# SAN FRANCISCO PLANNING DEPARTMENT

## Discretionary Review Full Analysis

*Date:* June 15, 2017  
*Case No.:* 2016-015049DRP  
*Project Address:* 645-647 Valencia Street  
*Permit Application:* 2016.11.14.2504  
*Zoning:* Valencia St NCT (Neighborhood Commercial Transit) Zoning District  
55-X Height and Bulk District  
*Block/Lot:* 3576/062  
*Project Sponsor:* Toby Morris, Kerman Morris Architects  
139 Noe Street  
San Francisco, CA 94114  
*Staff Contact:* Richard Sucre – (415) 575-9108  
[Richard.Sucre@sfgov.org](mailto:Richard.Sucre@sfgov.org)  
*Recommendation:* **Do Not Take DR & Approve the Project As Proposed.**

EAST ELEVATION PER EE R-3/ VARIANCE R-1, 8-25-16 DRAWINGS

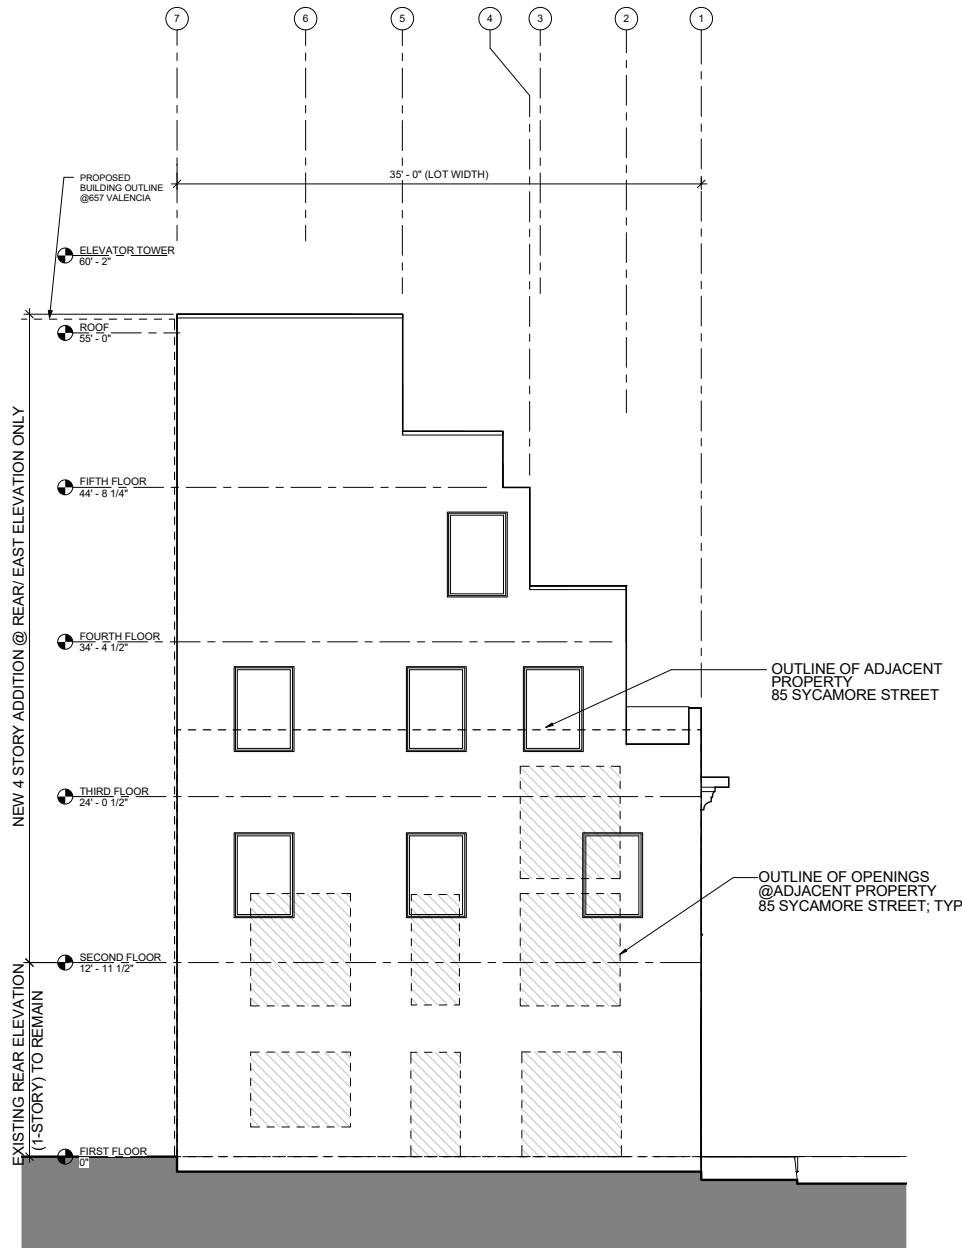
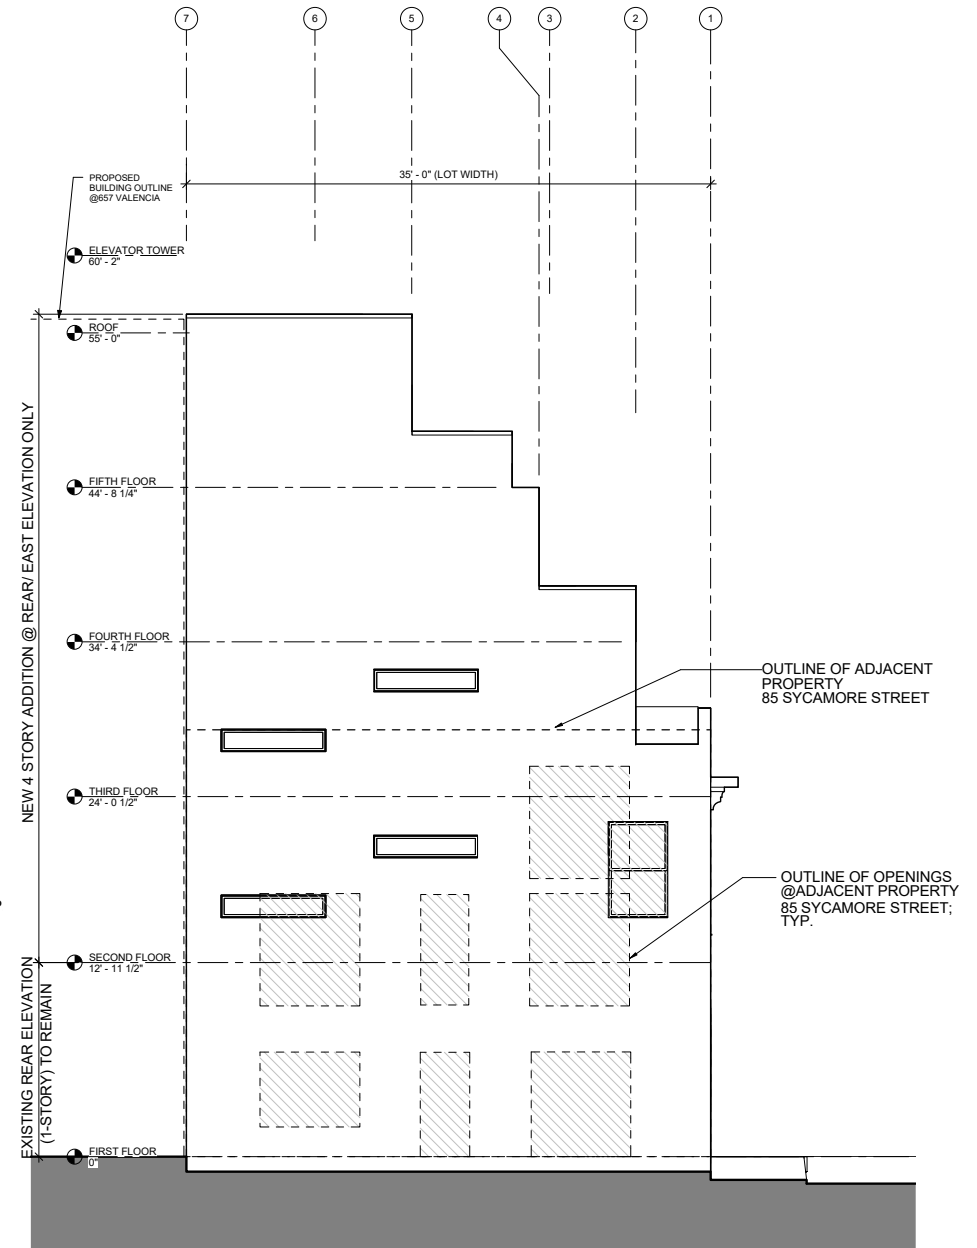
**Issue #3 – Privacy:** The Project Sponsor has agreed to modifications to the east façade to address privacy concerns.

NEW PROPOSED EAST ELEVATION PER INPUT FROM NEIGHBOURS ON 9-29-16

**Issue #5 – Alternatives:** As outlined above, the Project Sponsor has agreed to modifications to the east façade of the project through the incorporation of a light colored exterior material/finish, a reduction in the number of windows on the east façade, the addition of translucent glazing in the fenestration and privacy screens on the roof decks, and a protection plan for the neighboring tree (located in the ground floor garden of 85 Sycamore Street/2-4 Lexington Street. The Project Sponsor has stated that the other alternatives recommended by the DR Requestor would result in the loss of two of the seven dwelling units and would make the project financially infeasible.

**Issue #5 – Alternatives:** The Project Sponsor has revised the project to specify a light-colored exterior on the east façade, add privacy screens along the roof decks, and by reducing the number, size and translucency of the windows along the east façade. The Department supports the modifications to the east facade. The Department does not support the other modifications to the project’s exterior massing and design given the proposed revisions to the project since its first submittal in September 2013. The Department supports the proposed variances given the site constraints and the existing LGBT historic resource.

**Exhibit 1 - Graphic of open space corridor regarding massing concerns**

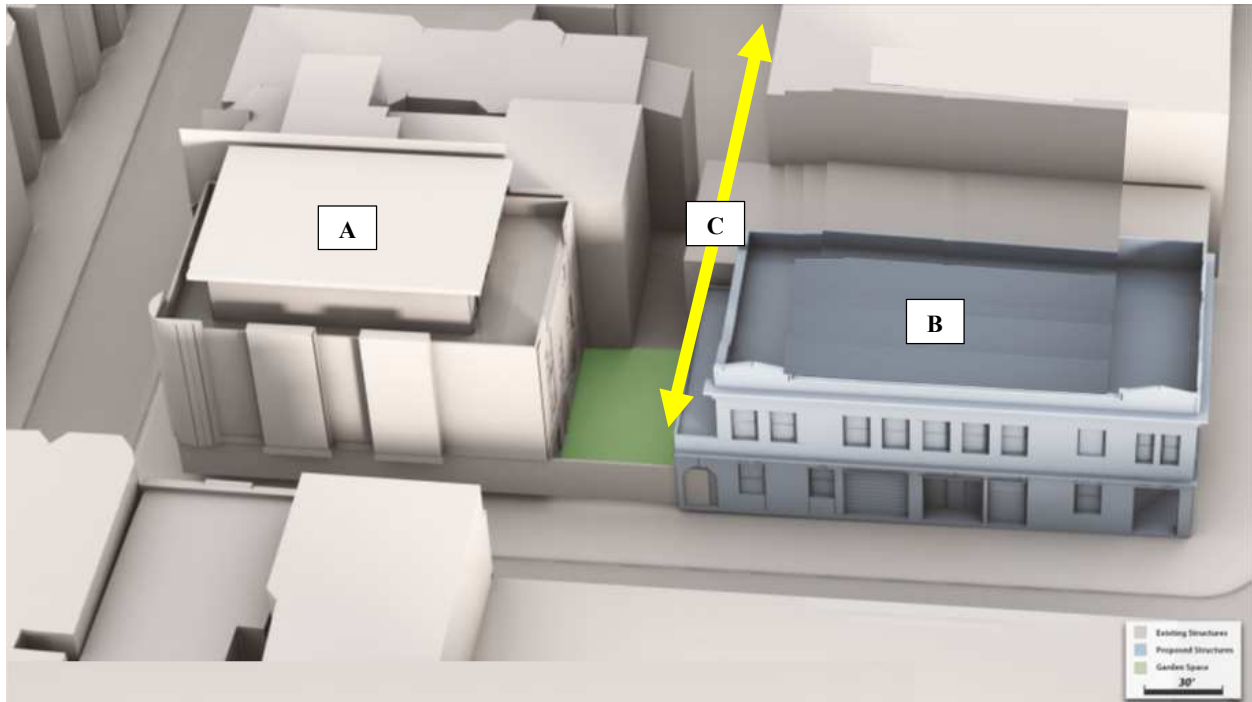
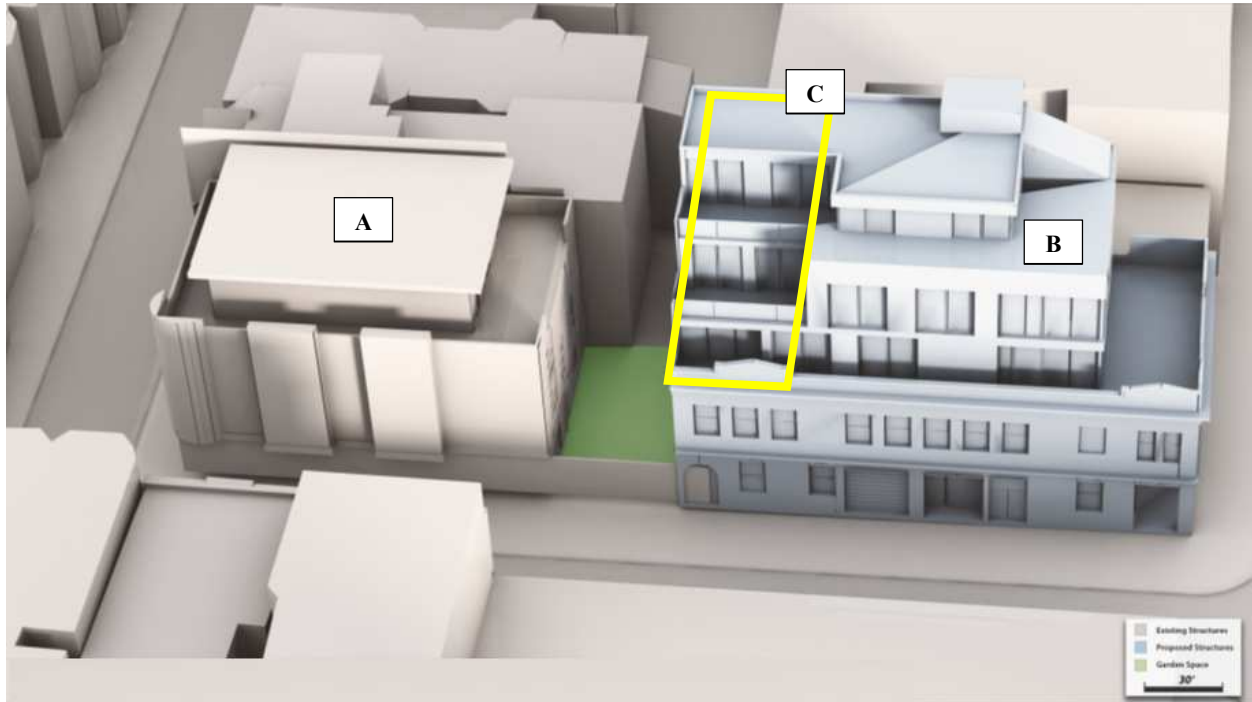
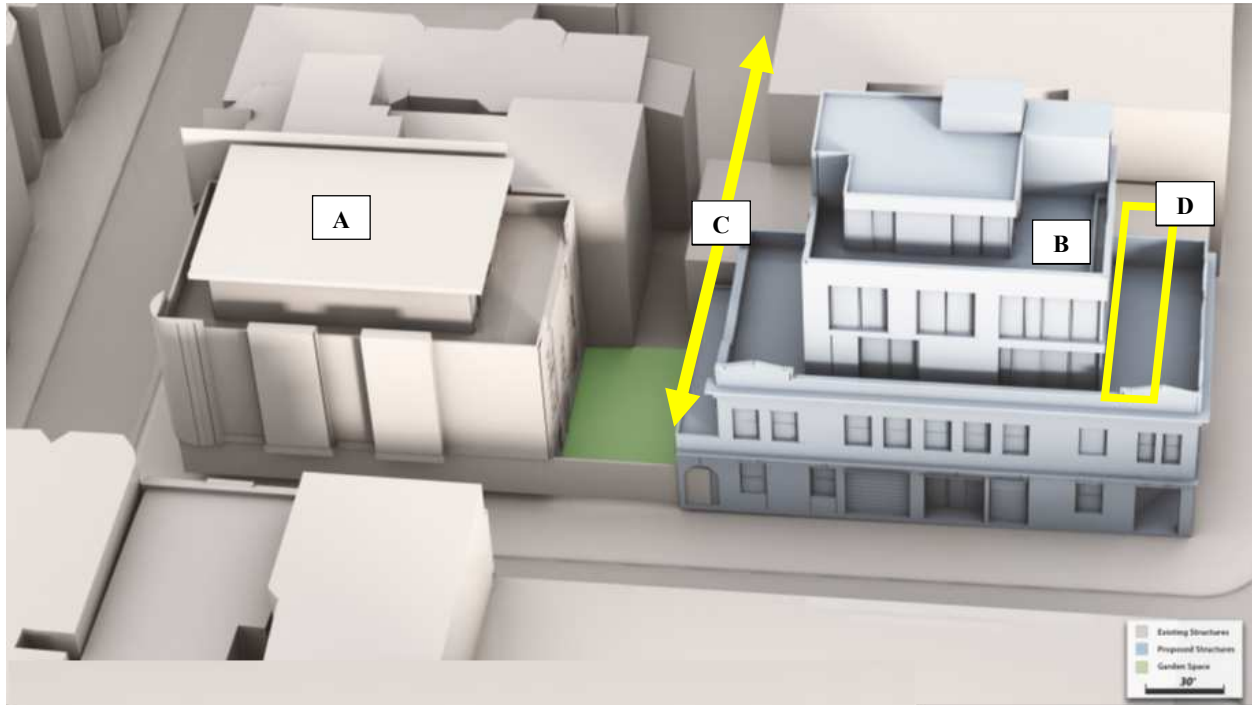
- A – 85 Sycamore-2-4 Lexington Street HOA
- B – Project site, currently “Elbo Room”
- C – Existing open space corridor

- A – 85 Sycamore-2-4 Lexington Street HOA
- B – Project site, currently “Elbo Room”
- C – Massing requiring rear yard variance

“After” – building without rear yard variance (proposal supported by neighborhood residents)

**After – proposed project, viewed from 3<sup>rd</sup> floor HOA resident bedroom**

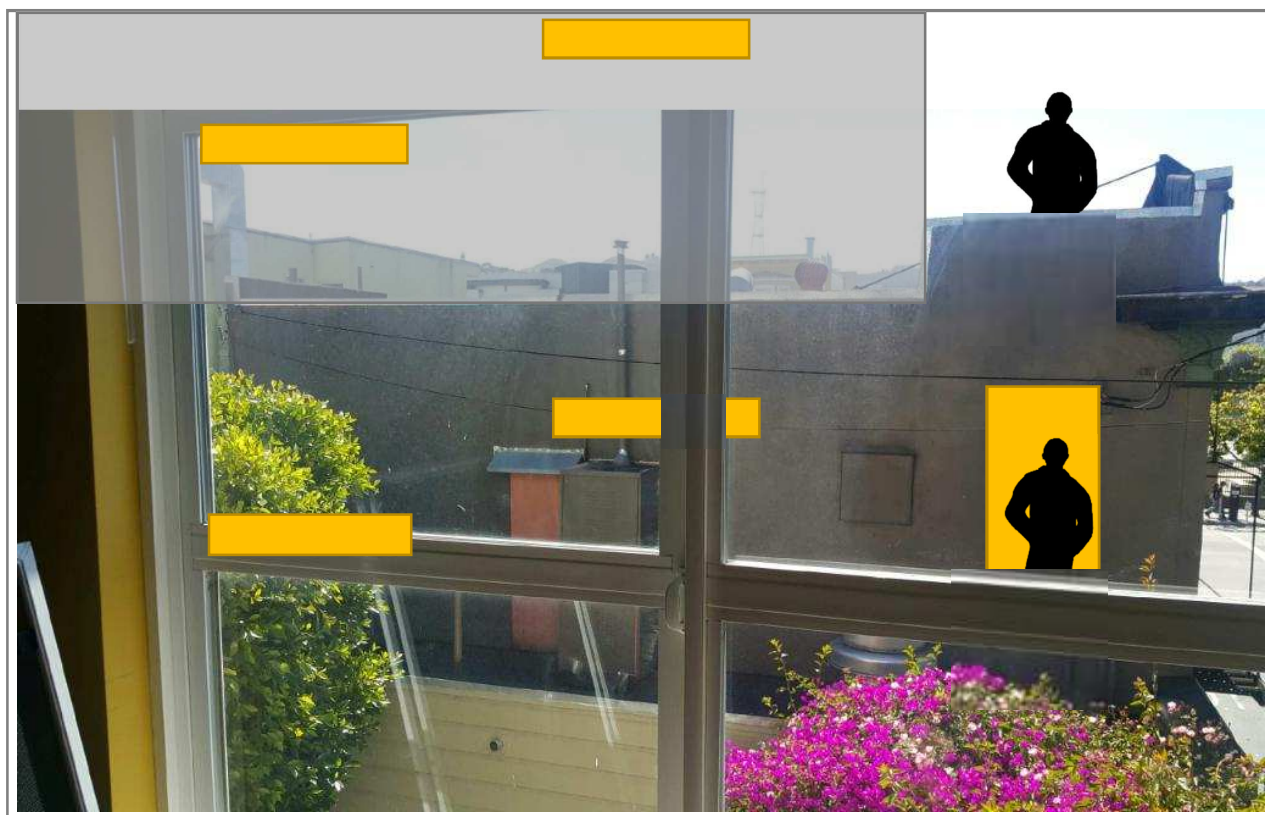
Current proposed project's window location. Windows & silhouettes will be on property line; closer than pictured.

**Exhibit 4 - Graphics, images & light study excerpts regarding light/shadow impact (cont'd)**

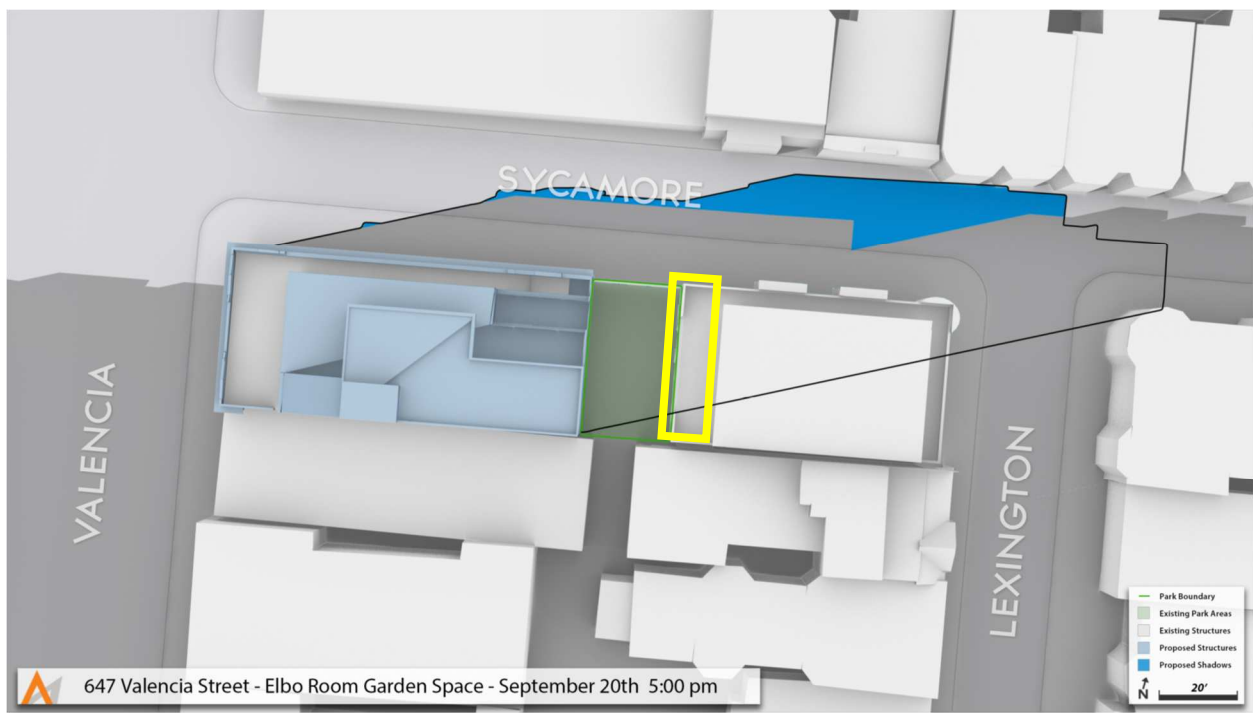
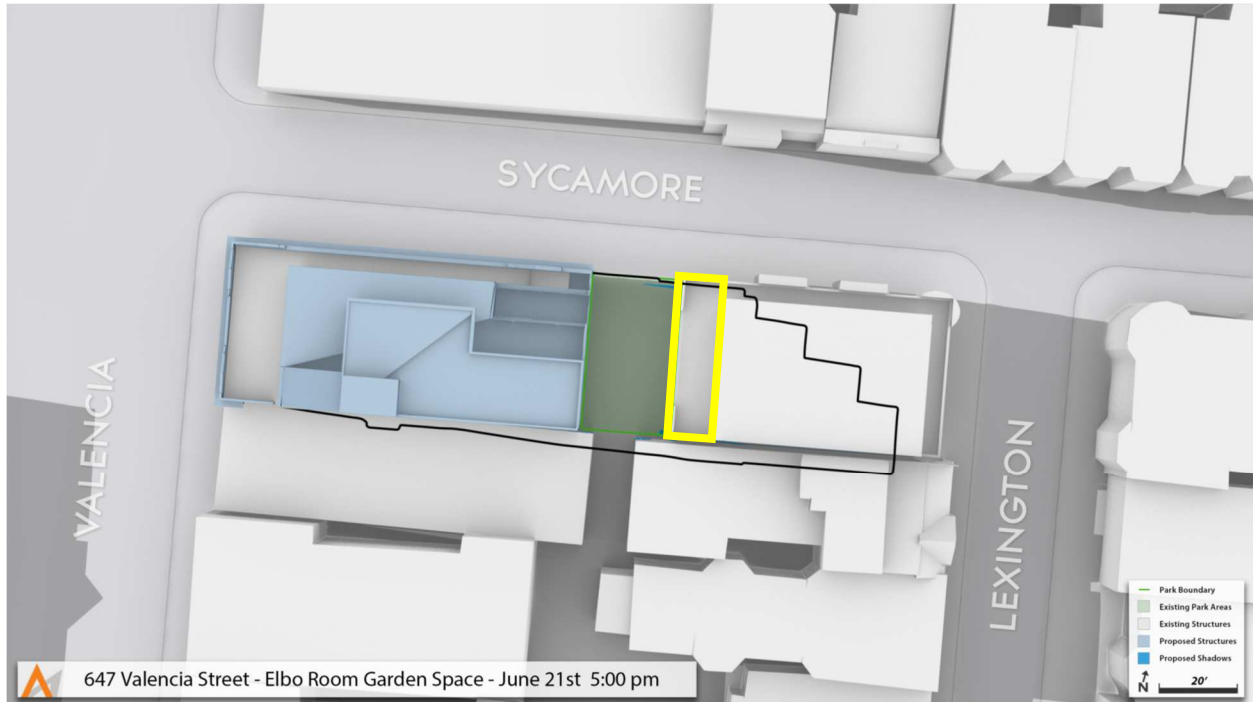
Graphics from light study: **100%** shadow cast on HOA rear yard and building at 5pm from proposed project – **yellow box area** indicates rear yard facing façade & living areas.

**Before** – June 6<sup>th</sup> 5pm: sunlight on rear façade/windows of HOA building and tree canopy

**Issue #1 – Access to Light/Building Setbacks:** The Department supports the project as proposed, and finds that the building setbacks appropriately and sensitively address the existing historic resource. The Planning Code does not possess provisions to address shadow impacts on private open space.
